LAND USE APPLICATION SUMMARY

Property Location: 1400 Park Avenue, 627 14th Street East, and 622 15th Street East
Project Name: 1400 Park Avenue Apartments
Prepared By: Lisa Steiner, Senior City Planner, (612) 673-3950
Applicant: BKV Group
Project Contact: Jeff Hemer
Request: To allow a new 6-story, 245-unit mixed use building.
Required Applications:

C8-1

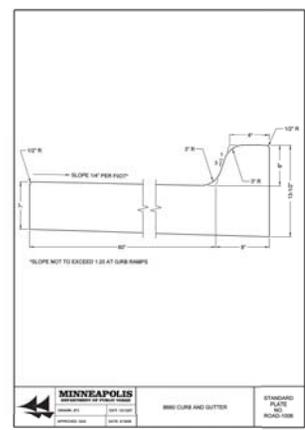
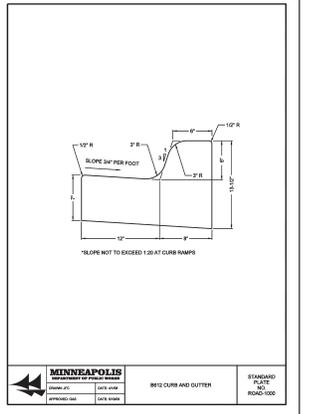
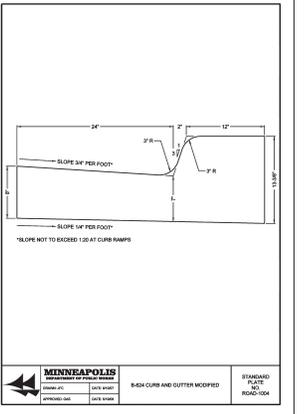
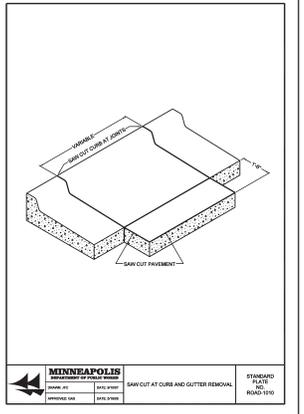
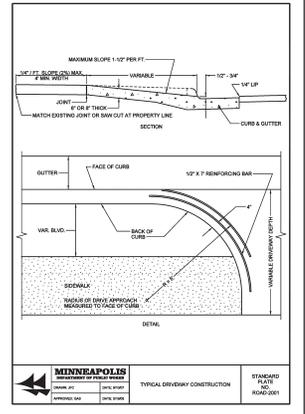
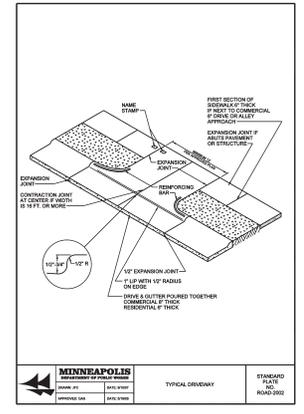
- The proposed driveway apron is shown incorrectly, with radius and curbs that exceed minimums. All driveway aprons shall be designed and constructed to City standards. All driveway aprons shall be shown graphically correct on all related plan sheets. Please refer to the following: http://www.minneapolismn.gov/publicworks/plates/public-works_road, and the standard plates included on Sheet C8-1 of the plans.

- The curb & gutter details included on Sheet C8-1 of the plans do not appear to match existing conditions. All curb & gutter in the Public right-of-way shall be designed and constructed to City standards, curb & gutter to be City Standard B624 Curb and Gutter. If curb replacement along Park Ave. S. is required, replacement curb shall be City Standard B660 Curb & Gutter. Please refer to the following: http://www.minneapolismn.gov/publicworks/plates/public-works_road. Add the following details from the ROAD-1000 Series - Curbs and Gutters to the plans: ROAD-1003 and Road -1006.

1 EAST ELEVATION
 1/8" = 1'-0"

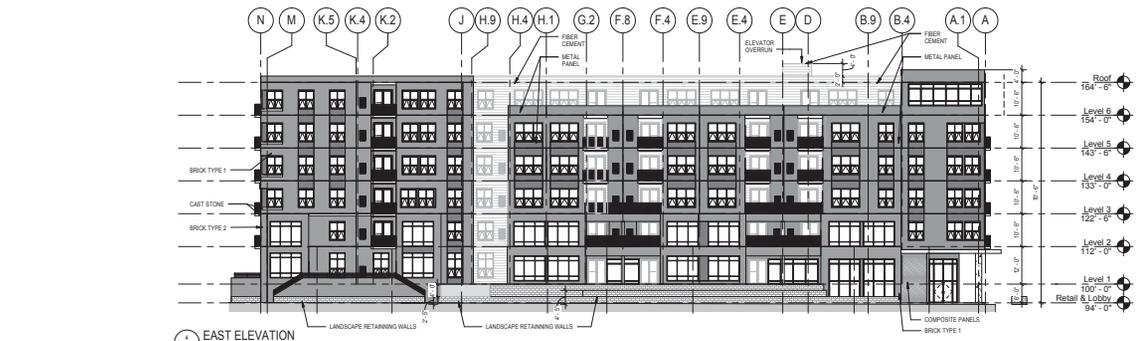
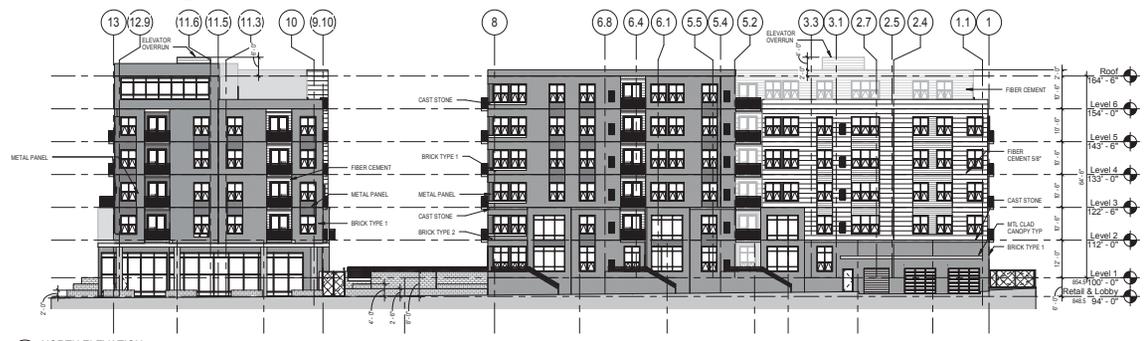
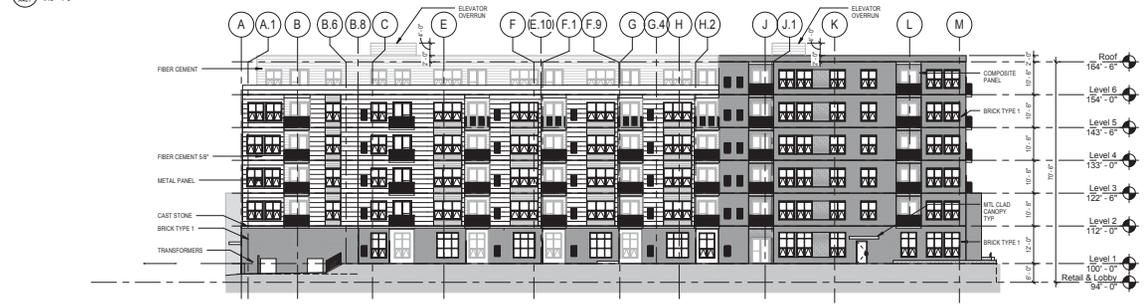
- **Visual interest.** There are blank, uninterrupted walls exceeding 25 feet in length, including a 48 foot blank wall on the east elevation and a 40 foot blank wall on the west elevation. These require alternative compliance. The blank wall on the east elevation is located at the southernmost portion of the elevation where two stairways lead to first floor units. Due to the grade of the site, six feet of the blank wall is actually at the level of the underground parking garage area. The applicant would plant several shrubs and ornamental trees between the sidewalk and this blank wall (some on the property and some on public right-of-way) which would mitigate the impact of the blank wall. Staff finds that this alternative meets the intent of the requirement and recommends granting alternative compliance for this wall. The blank wall on the west elevation is located at the northernmost portion of the elevation. There is a six-foot fence that would obscure this blank wall from the public street and the adjacent property. Because of the limited public visibility of this blank wall, staff finds that granting alternative compliance is reasonable.

- **Windows.** The project is not in compliance with window requirements on the first floor of the Park Avenue or 14th Street East elevations. The applicant is proposing 18 percent windows on the ground floor along Park Avenue, where 20 percent is required. There is an approximately 9 foot grade change on the site. Because of how the applicant has chosen to account for this grade change, the first level of the building is about six feet from grade along Park Avenue and 14th Street. This has a significant impact on the window requirement calculations on these elevations, since windows are measured between 2 and 10 feet from adjacent grade. On Park Avenue, there are several sliding glass doors on the first level of this elevation which increase the amount of glass but are not included in the window percentage calculation. Since the parking garage does not extend above grade in the nonresidential portion of the building, the proposal exceeds its 30 percent nonresidential window requirement on Park Avenue by 32 percent. Staff recommends granting alternative compliance due to the increased window area in the directly adjacent nonresidential area of this elevation and the additional glass that is provided in the sliding glass door areas. On 14th Street East, the applicant is proposing to incorporate only 157 square feet (12 percent) of glass (measured between 2 and 10 feet from adjacent grade), where 256 square feet (20 percent) would be required. This window calculation is similarly impacted by the chosen first floor elevation. While the proposal exceeds the nonresidential window requirement on this elevation, those windows are 60 to 120 feet from the nearest residential window and in that case does not adequately mitigate the reduced residential windows. In the submitted renderings of the building, the garage doors are shown to be mostly transparent. This is not indicated on the elevation drawings. However, staff finds that incorporating the additional required 99 square feet of windows in the transparent garage doors or the adjacent pedestrian door would adequately mitigate the negative impacts of the proposal. The two garage doors are 75 square feet each, so two-thirds of the garage door would need to be transparent, or less if glass is incorporated in the pedestrian door. Therefore, staff recommends a condition of approval requiring compliance with the residential window requirement on this elevation, but with the flexibility that transparency in the garage or pedestrian doors can be utilized to satisfy that requirement.

- Identify height of all retaining walls/planters
- The east and north elevations are not meeting minimum window area requirements for site plan review. First floor minimum window area is measured between 2 and 10 feet above the adjacent grade. Alternative compliance will be required if not meeting the minimum window area requirements. (530.120)
